**TARGETED INTERVENTIONS UNDER THE  
RURAL ROAD INVESTMENT PROGRAMME IN  
MOZAMBIQUE (PHASE 1)**

**Construction/Progress Report**

**CLIENT PROJECT REPORT CPR 470**

**by K Mukura, S Done and Dr J Rolt**

**Grading curves of the gravel on the Zero Mopeia Road**

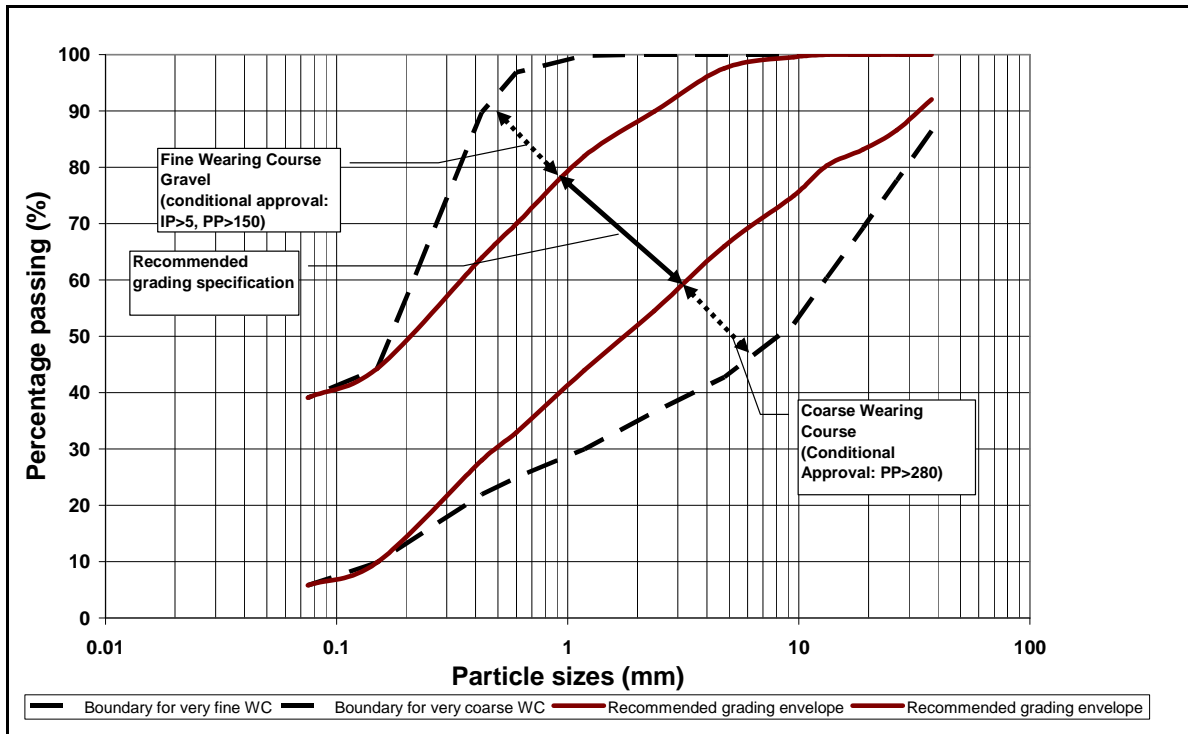
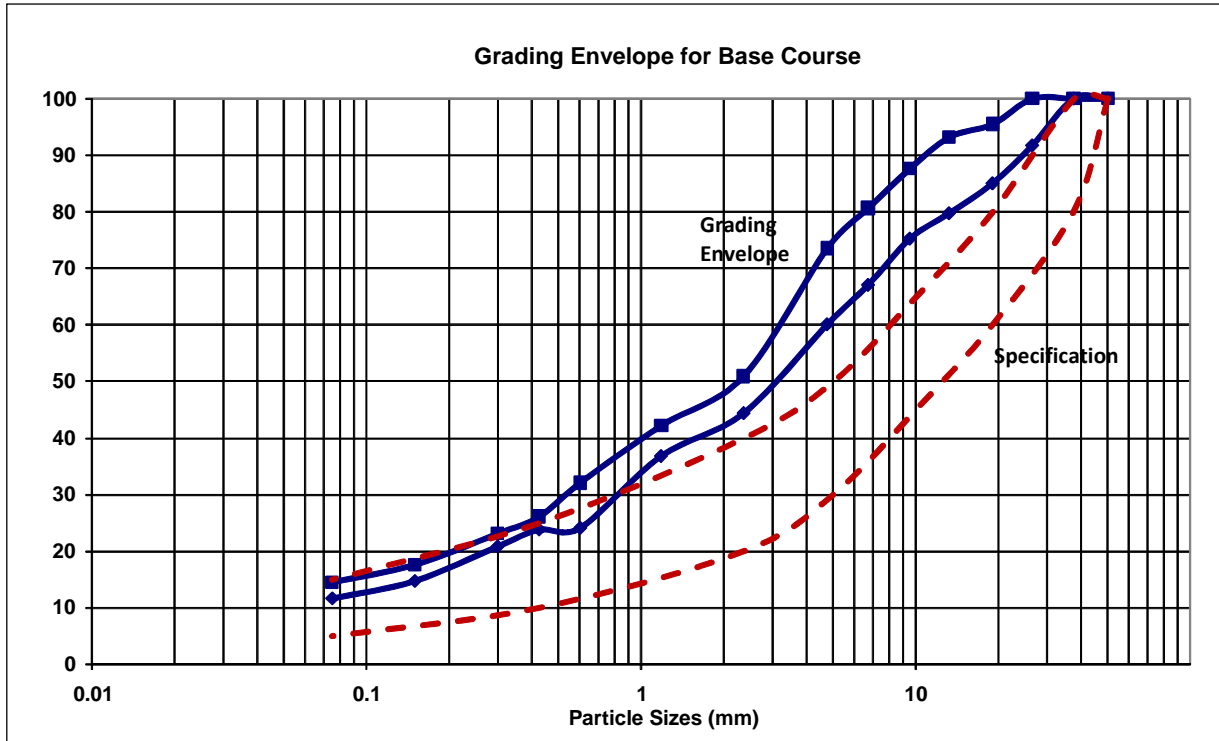
1. The area is unusual in that good gravel is available at economic haul distances, unlike most other projects under RRIP. In-situ sandy subgrade material was used for the formation. The wearing course was constructed of fine quartzitic gravel with a proportional content of fine red silt. This makes the material perfect for use as wearing course. The graphs below show the grading of the gravel in comparison with internationally accepted standards (TRL report '*Increased application of labour based methods through appropriate engineering standards*').

2. This material will also be used as roadbase material in the second stage of the construction. The wearing course will become the subbase and the roadbase will be constructed with similar gravel. It is therefore necessary to assess the quality of the gravel against specifications for natural gravel roadbases for sealed roads. The graph below shows that it is a little fine.

5. Higher compaction gives substantial benefits because the wear resistance of the wearing course is enhanced and uneven settlement in the lower layers is prevented. Thus it is important to test compaction achieved during the construction of gravel roads. This applies to both the subgrade and the wearing course. For remote projects where laboratory facilities are unavailable it may be necessary to use a 'method specification' type of quality assurance.
